# AXOD/AXODE (AX4S) UPDATE HANDBOOK

# INTRODUCTION

This updated version of the AXOD "Update Handbook" will also cover the changes that occurred in the 1991 model year, when electronic controls were adapted to the AXOD transaxle, making it an AXODE, and now called an AX4S transaxle. We have included the changes on the AX4S transaxle up through and including model year 2002.

Figure 94

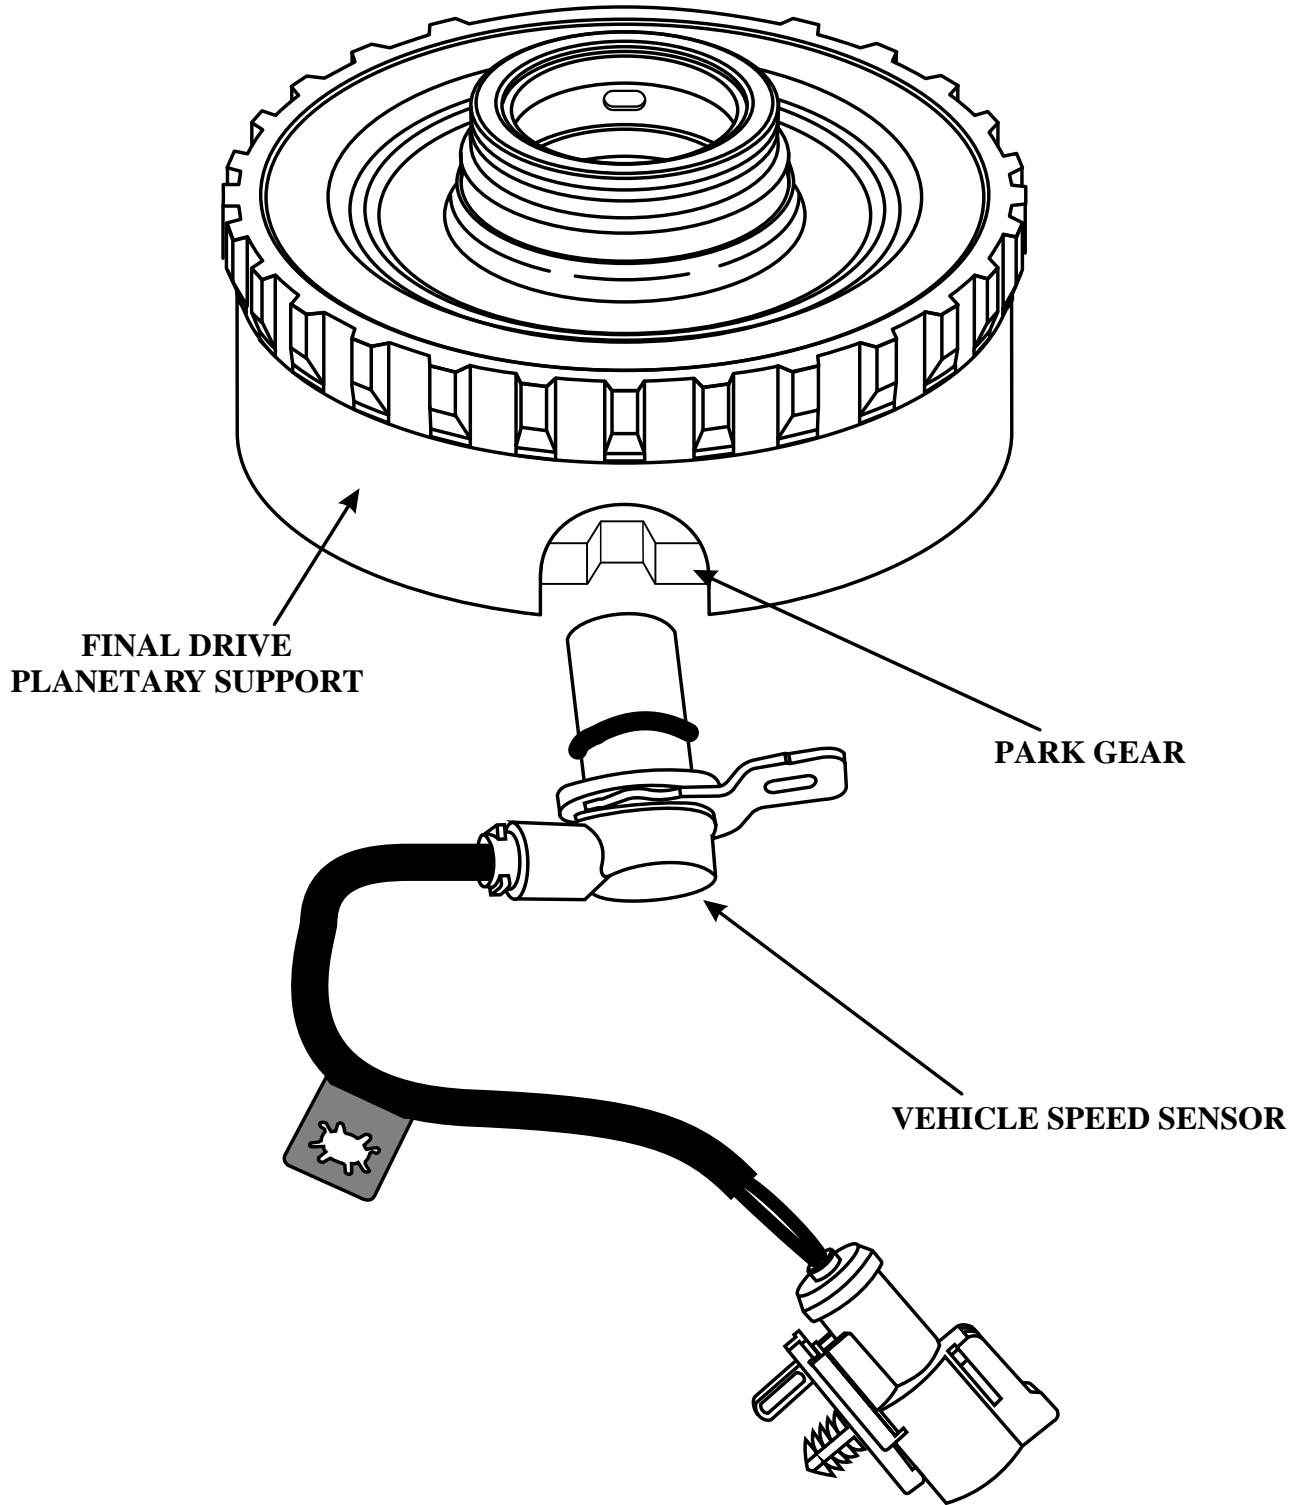
- (1) TRANSAXLE CASE - Changed to accommodate mounting the new design speed sensor so that it is in line with the planetary support and the park gear.
- (2) FINAL DRIVE SUPPORT - Changed to accommodate mounting the new design speed sensor and now has a "*cut out*" for the speed sensor to look through at the park gear, as shown in Figure 94.

Figure 101

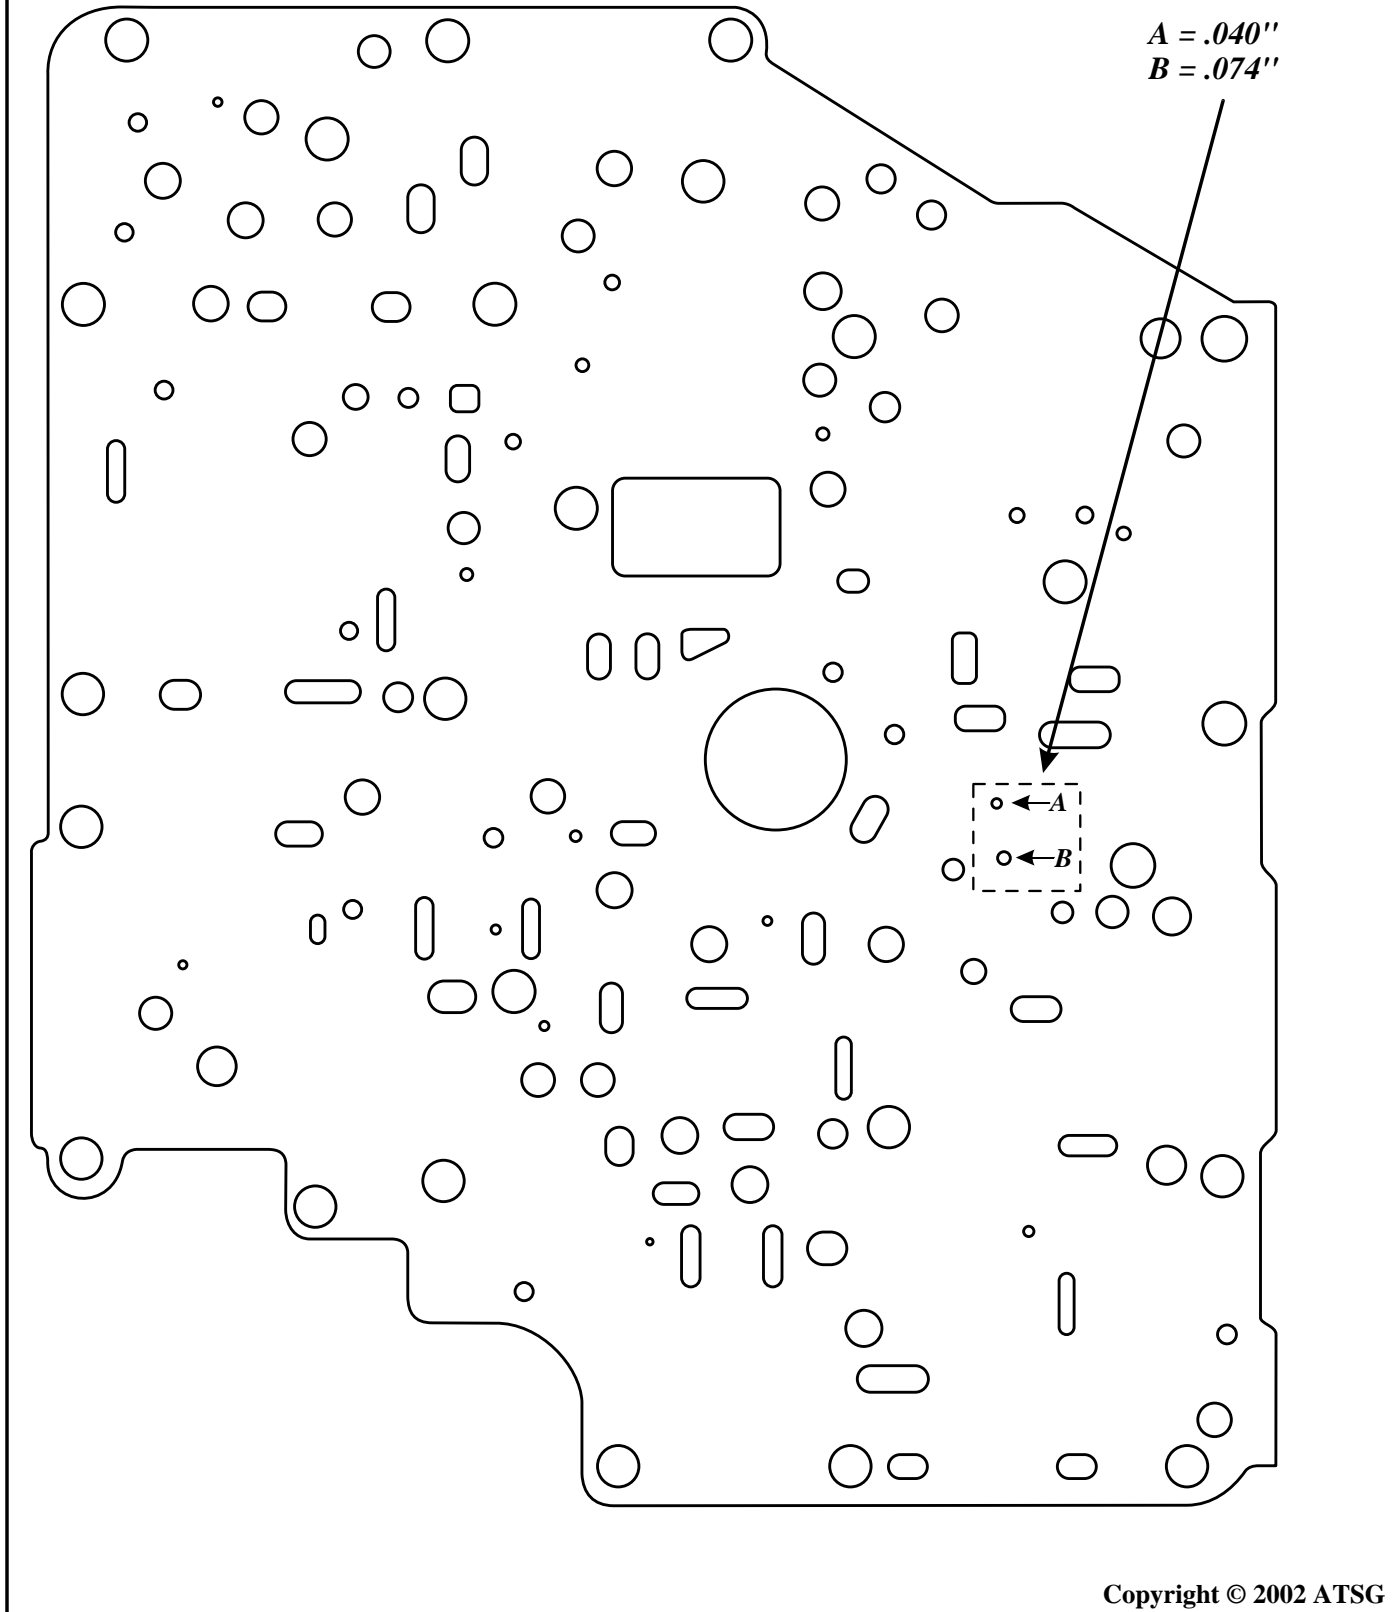
**CAUSE:** The cause may be, a valve body spacer plate designed for the Taurus, Sable, Continental passenger car family, has been installed on a Windstar Van, creating a harsh 1-2 upshift. If the Windstar Van valve body spacer plate, is installed on the Taurus, Sable, Continental family of vehicles, the result will be a soft or flared 1-2 upshift. ***Obviously these two spacer plates are different.*** Refer to Figures 101 and 102, using the two holes over the 1-2 capacity modulator valve area, for identification.

**CORRECTION:** Install the proper valve body spacer plate for the Ford family that you happen to be servicing at this time. Refer to the illustration in Figure 101 to identify the valve body spacer plate for the Windstar Van. Refer to the illustration in Figure 102 to identify the valve body spacer plate for the Taurus, Sable and Continental family.

Figure 103

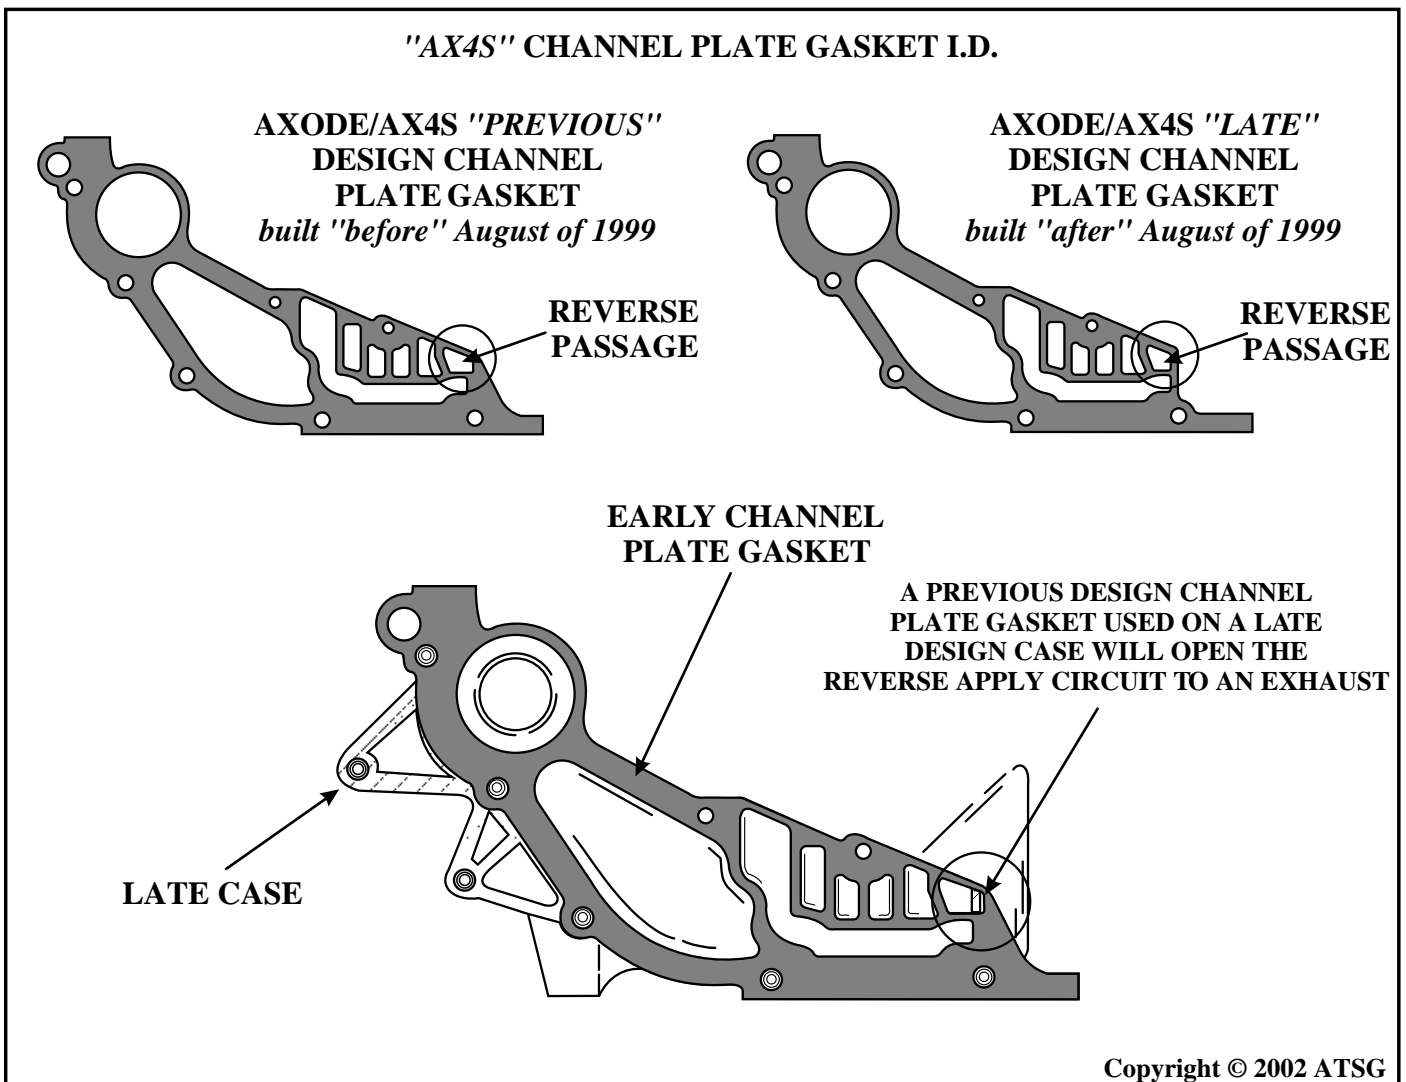
**CAUSE:** The cause may be, that the *Previous Design* Channel Plate Gasket, was used on a *Late Design* case as shown in Figure 103. When this happens, Reverse apply pressure will be exhausted back into the case because of the gasket hanging over the case casting.

**CORRECTION:** AX4S-Refer to Figure 103 to identify the correct Channel Plate Gasket for the application of vehicle you are working on.  
AX4N-Refer to Figure 104 to identify the correct Channel Plate Gasket for the application of vehicle you are working on.
